Enclosure 3
Westinghouse APP-GW-GLR-607, Revision 2
(NON-PROPRIETARY VERSION)
(63 pages including cover page)

Changes to Passive Core Cooling System Condensate Return

April 2015

Figure 8: Personnel Airlock Gutter Modification Schematic

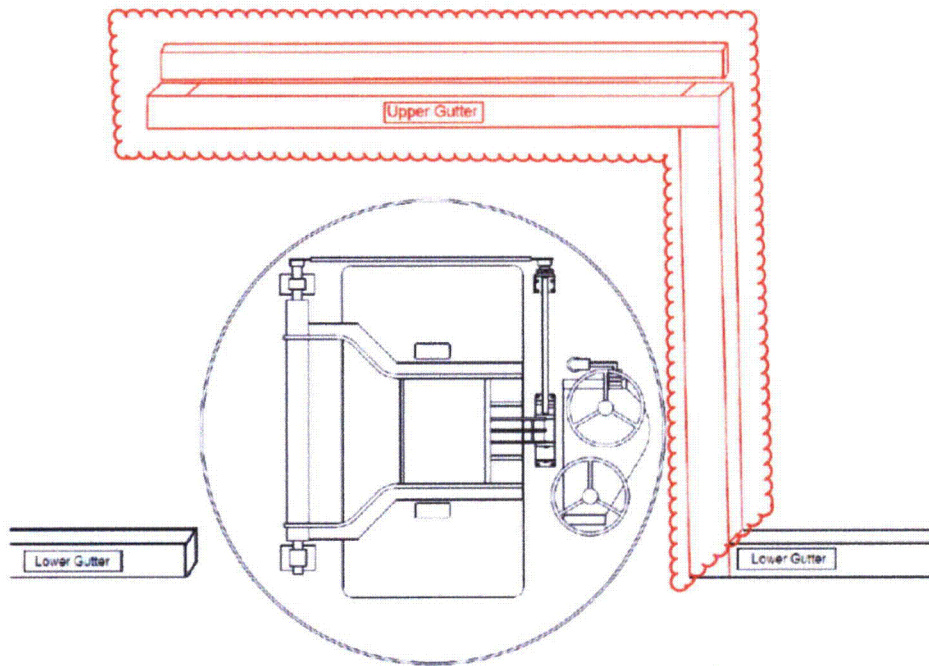
The original IRWST gutter was routed to the edges of the Upper Personnel Airlock and Upper Equipment hatch. [

] ^{a, c} The IRWST gutter will be modified to have an upper gutter above each of the hatches that connects with the existing gutter. The extended gutter is of the same size as the sections which currently interface with the sides of the hatches. The gutter is sloped the same as the existing portions of the gutter. The extended portion of the gutter above the Upper Personnel Airlock is routed to interface with the lower portion of the gutter. Figure 8 shows a schematic of the proposed modification to the IRWST gutter to above the Upper Personnel Airlock. The Upper Equipment Hatch is similarly treated.

Figure 3.8.2-1 (Sheet 3 of 3)

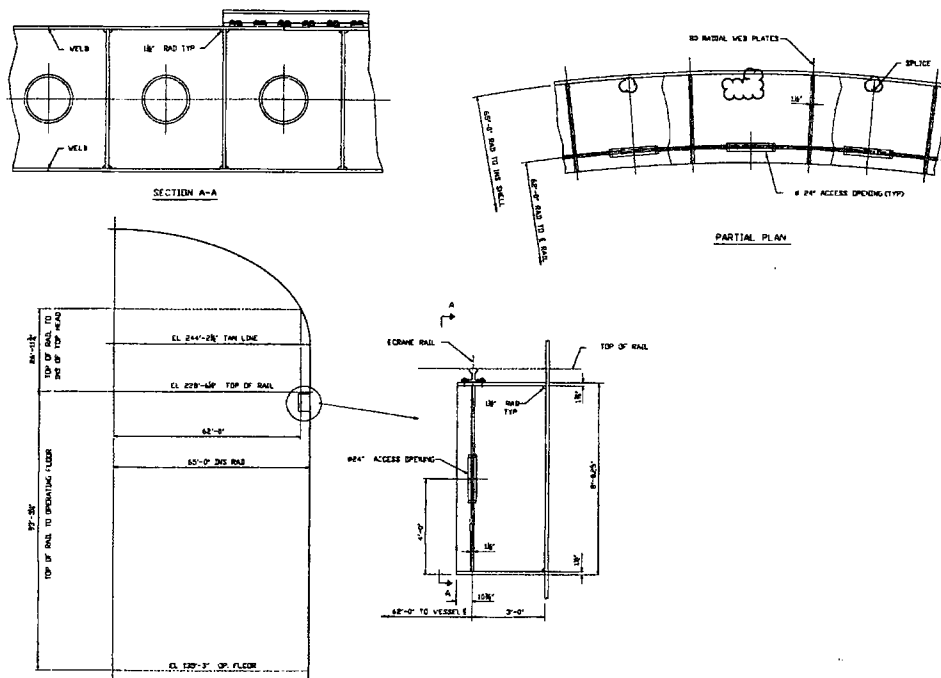
Pictorial detail of the PCG is shown in DCD Chapter 3. Figure 3.8.2-1 (Sheet 3 of 3) shows the fabrication holes in the top right figure. As the fabrication holes in the PCG would be blocked in the modified configuration, this detail would be removed from this figure. The changes are shown in Appendix B.

Pictorial detail of the Polar Crane Girder is shown in DCD Figure 3.8.2-1 (Sheet 3 of 3), Containment Vessel General Outline, and shows the fabrication holes in the top right figure. As the fabrication holes in the PCG would be blocked in the modified configuration, this detail would be removed from this figure.

Passive Core Cooling System
Piping and Instrumentation Diagram (Sheet 2 of 3)

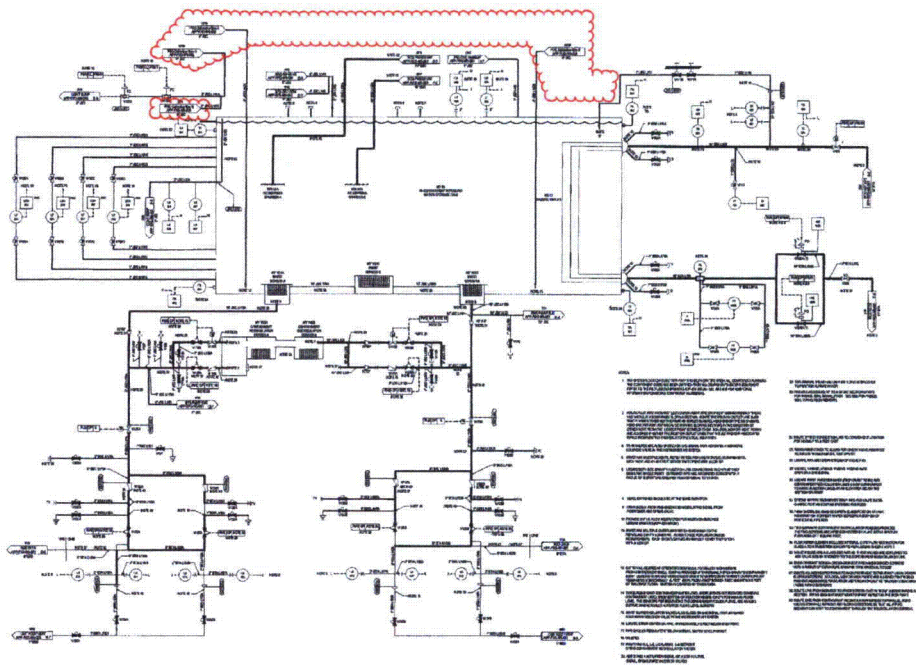
- Subsection 6.3.1.1.1 would be updated to describe the downspouts in the safety-related design criteria.
- Subsection 6.3.2.1.1 will be updated to include the intermediate collection points of the safety-related gutter arrangement.
- Subsections 6.3.2.2.7 and 6.3.2.2.7.1 would be updated to clarify the number of screen sets in the PXS and to which set of screens the criteria in this section apply.
- Subsection 6.3.2.2.7.2 would be updated to clarify the condensate return gutter arrangement related to LOCA operation.
- Figure 6.3-1 will be relabeled Figure 6.3-1 (Sheet 1 of 3). This editorial change is the only change made to this figure. No technical changes are made.
- Figure 6.3-2 will be relabeled Figure 6.3-1 (Sheet 2 of 3). On relabeled Sheet 2, the IRWST gutter has been relocated to a new sheet 3 of the PXS P&IDs. Sheet 2 has been

modified to include continuation flags for condensate returning to the IRWST originating from PXS Collection Boxes A and B in the IRWST gutter.

Passive Core Cooling System
Piping and Instrumentation Diagram (Sheet 3 of 3)
(REF) PXS 005

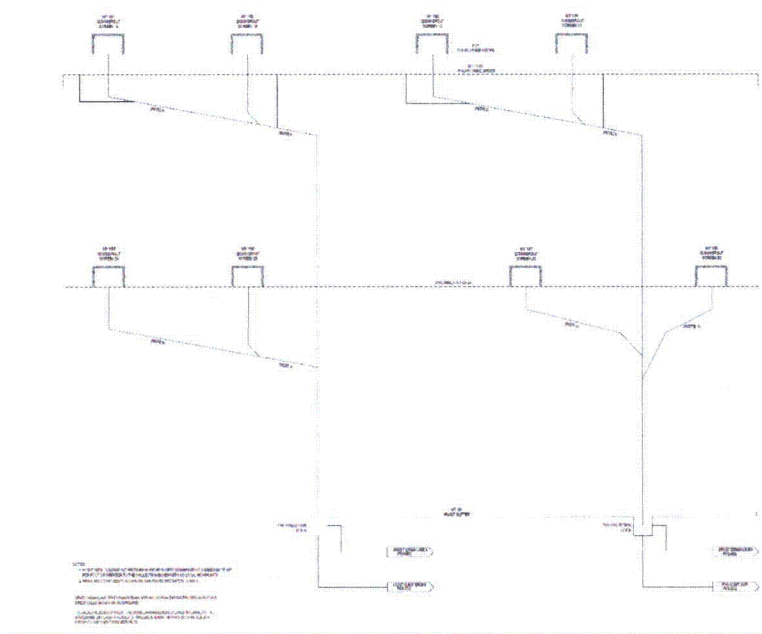
- Figure 6.3-1 (Sheet 3 of 3) is a new P&ID sheet and will be added to the licensing basis. This new figure shows the relocated IRWST gutter and the screens and piping comprising the PXS downspouts originating from the Polar Crane Girder and internal stiffener.
- Figure 6.3-2 will not be used.
- The Chapter 6 List of Figures will be updated to reflect the PXS figure relabeling and the additional PXS P&ID sheet.
- Reference to Figure 6.3-2 in subsection 6.3.2.1 is changed for consistency.

Figure 19E.4.10-1

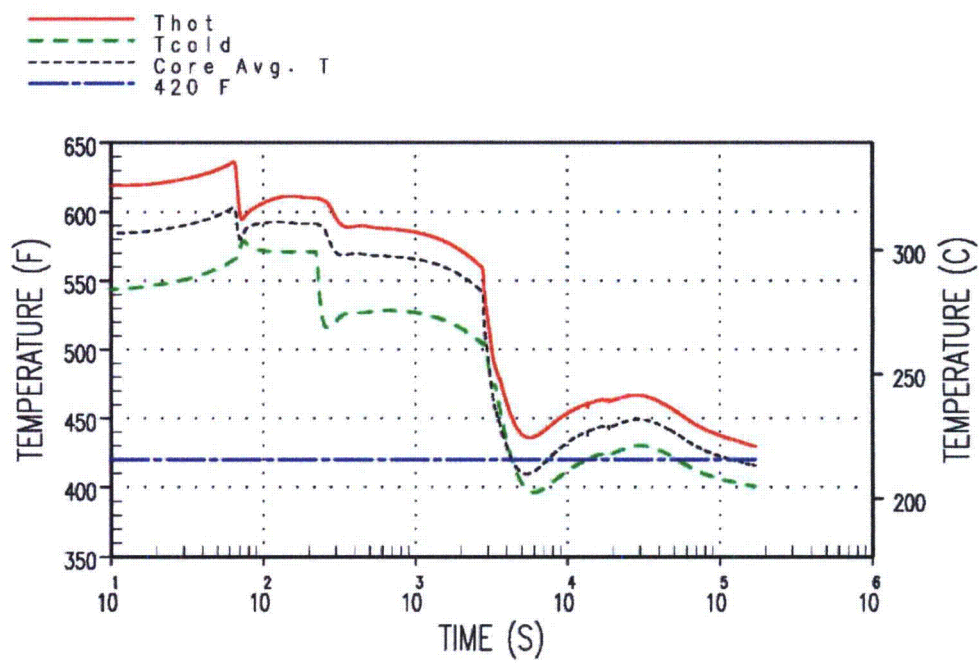
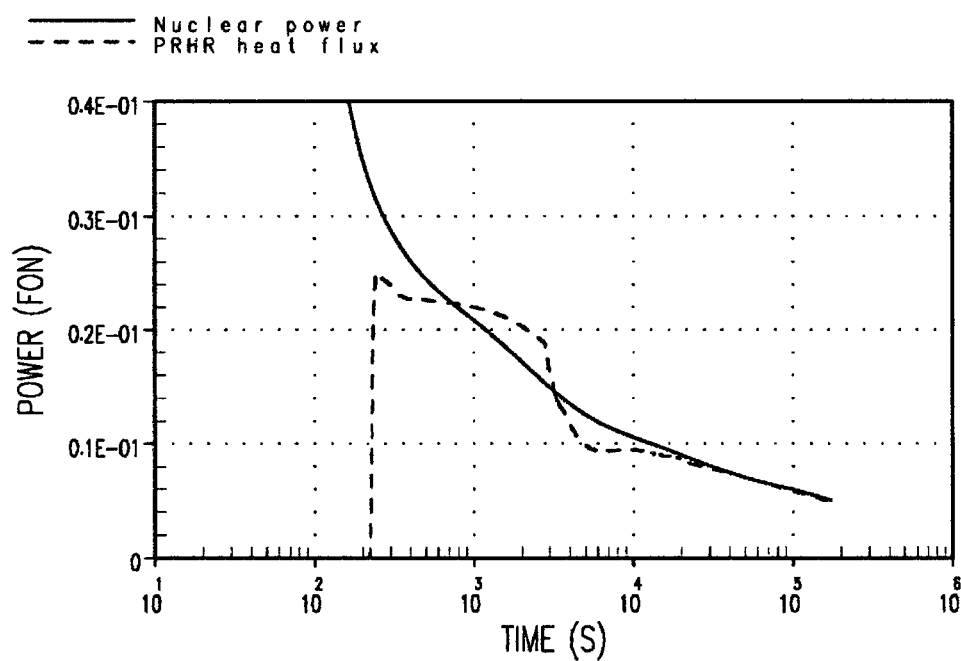
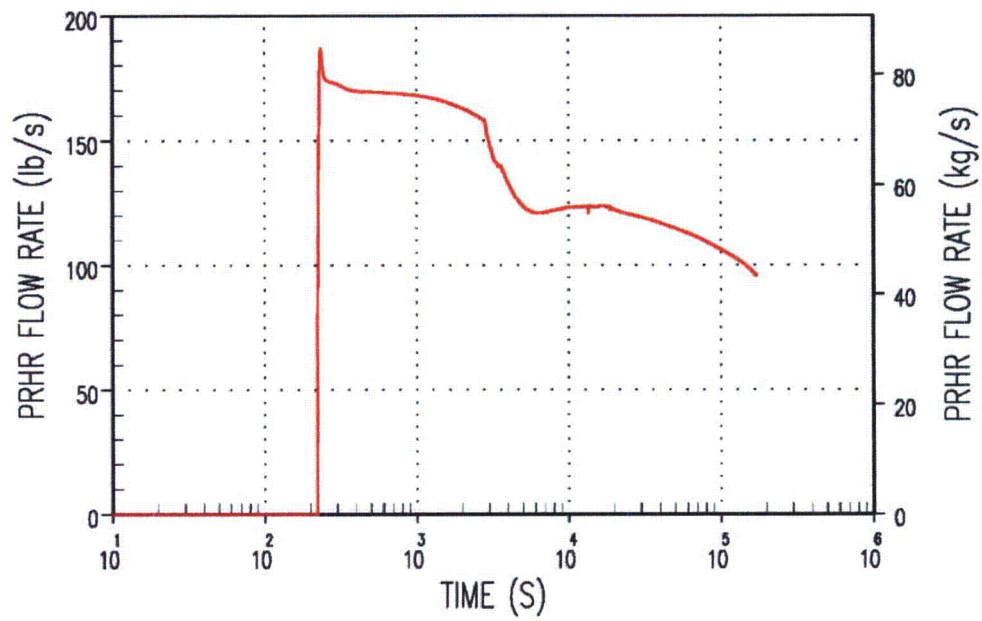
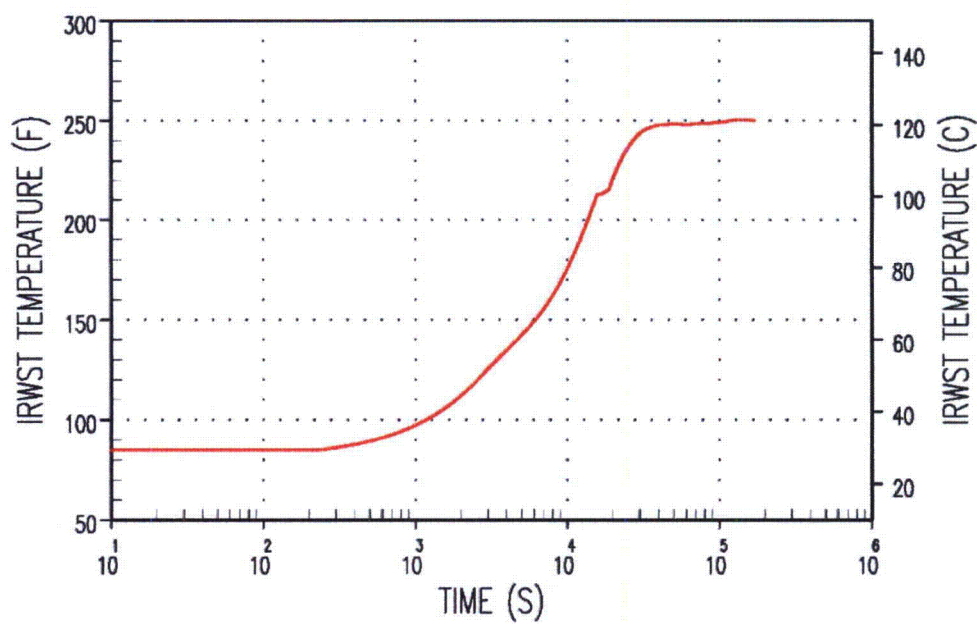
Based on the updates to the safe shutdown evaluation, the supporting licensing basis tables and figures need to be updated to reflect the current design. Section 19E.4.10.2, Table 19E.4.10-1, and the supporting figures, Figure 19E.4.10-1, -2, -3, and -4 will be updated by this change package.

Changes to Chapter 19 would include changes to subsection 19E.4.10.2, Shutdown Temperature Evaluation, to describe the analysis methodology for a non-LOCA shutdown event, the time for the cold leg and core average temperatures to reach the specified safe, stable condition after shutdown following a loss of ac power event, and updates to corresponding tables and figures, which further detail the sequence of events. The changes to Chapter 19 are shown in Appendix B.

The safe shutdown temperature evaluation was revised to address the effects of the design modifications and supporting analyses and calculations of condensate return to the IRWST on PXS performance. **The revised evaluation is reflected in the description provided in section 7.4 and subsection 7.4.1.1.** The resultant changes to the Chapter 19 shutdown temperature evaluation are shown in text revisions to subsection 19E.4.10.2, changes to Table 19E.4.10-1, and changes to Figures 19E.4.10-1 through 19E.4.10-4.

Shutdown Temperature Evaluation,
 RCS Temperature
 Figure 19E.4.10-201

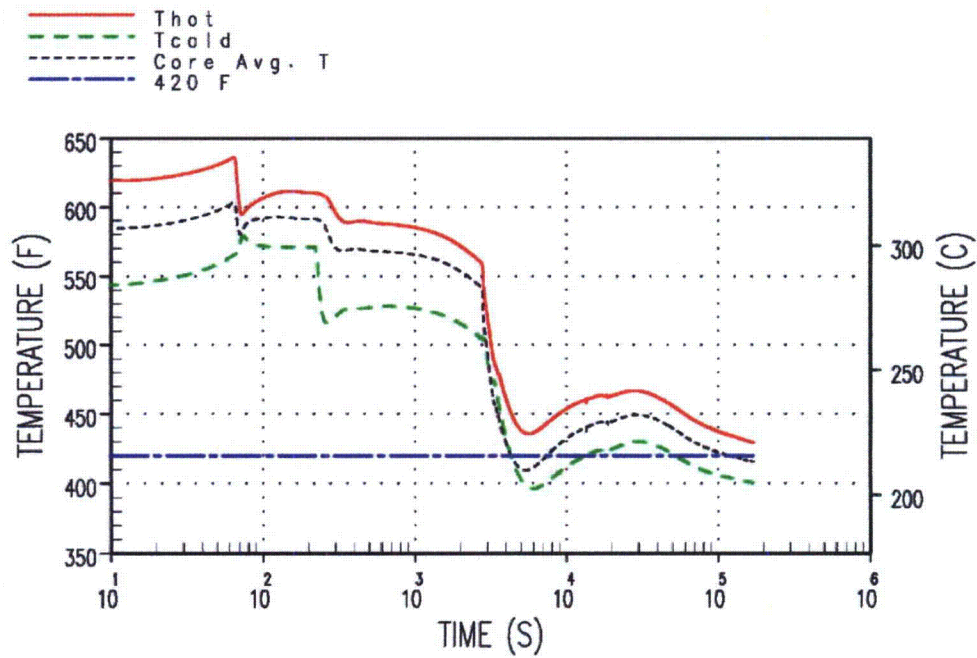
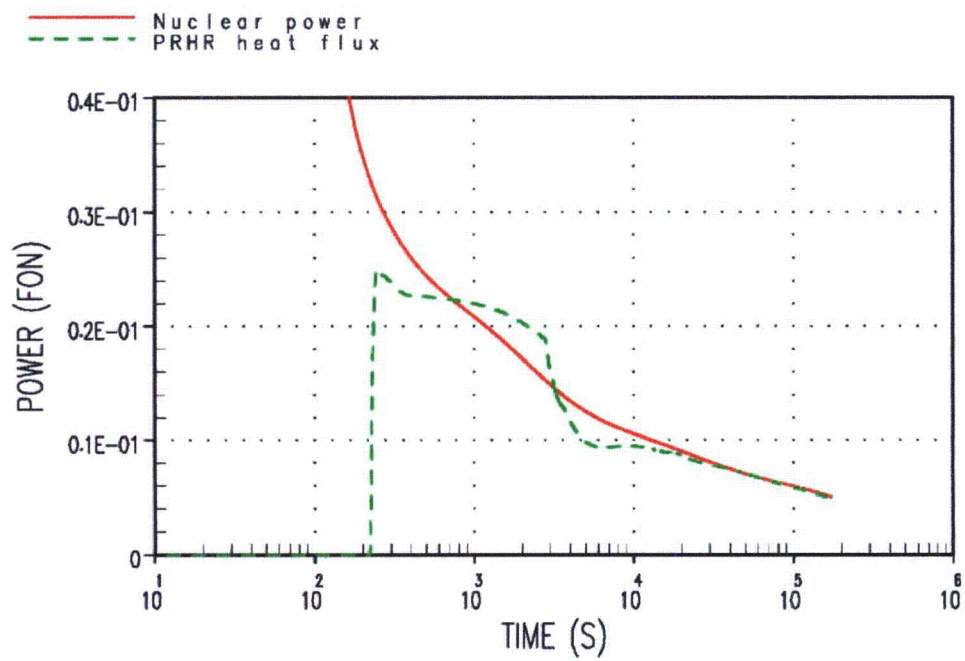
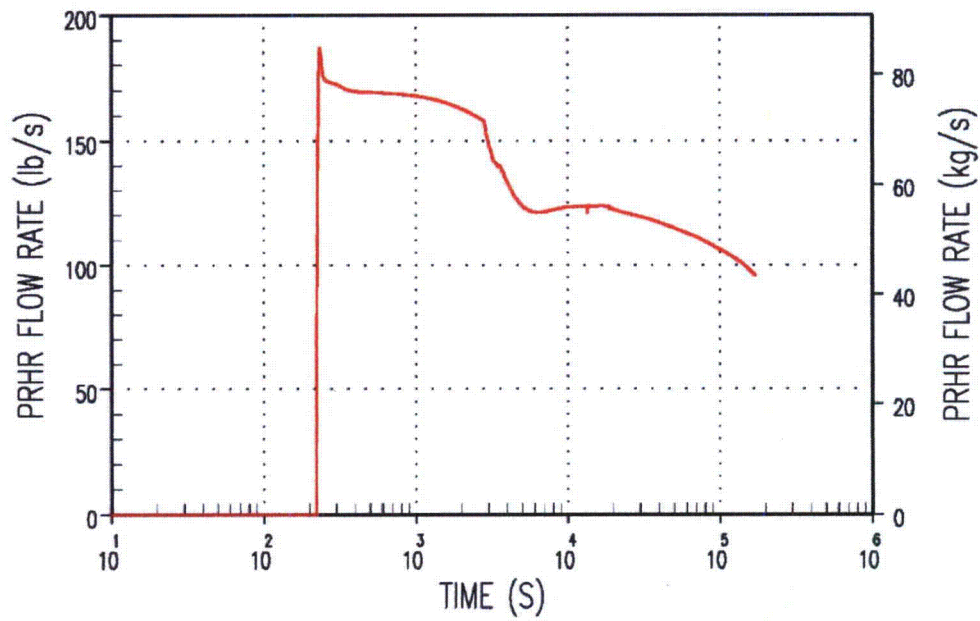
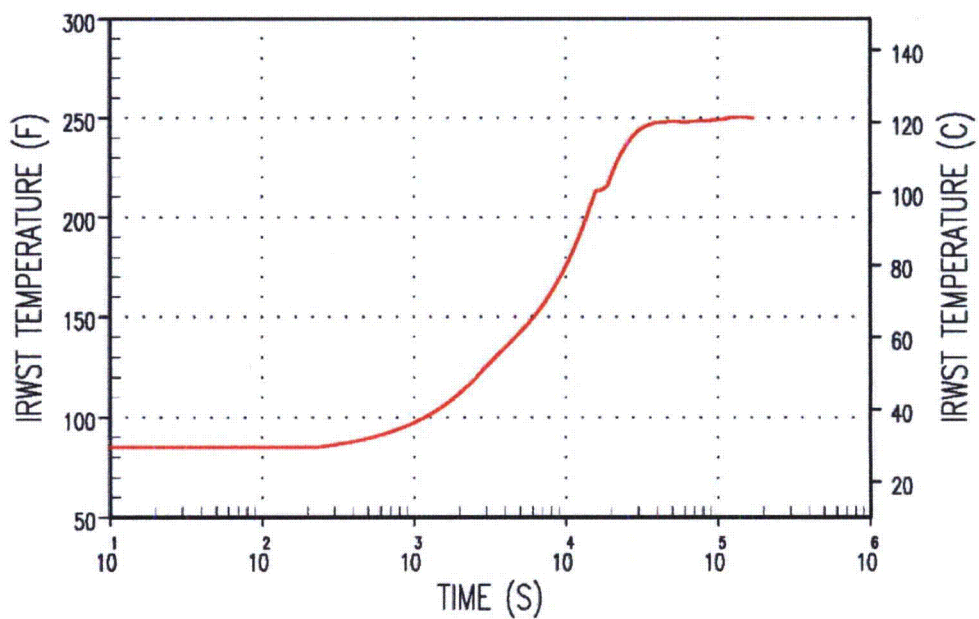
4. COLA Part 2, FSAR Section 19E, Table 19E.4.10-201, Sequence of Events Following a Loss of AC Power Flow with Condensate from the Containment Shell Being Returned to the IRWST, will be revised to show the modified timings for events resulting from the revised condensate return analysis methodology. Table 19E.4.10-201 is shown in the attachment to this enclosure.
5. COLA Part 2, FSAR Section 19E, Figures 19E.4.10-201 through 19E.4.10-204, will be revised to show the modified results based on the revised condensate return analysis methodology. Figures 19E.4.10-201 through 19E.4.10-204 are shown in the attachment to this enclosure.
6. COLA Part 7, Departures and Exemption Requests, Departure LNP DEP 3.2-1 will be revised as shown below:
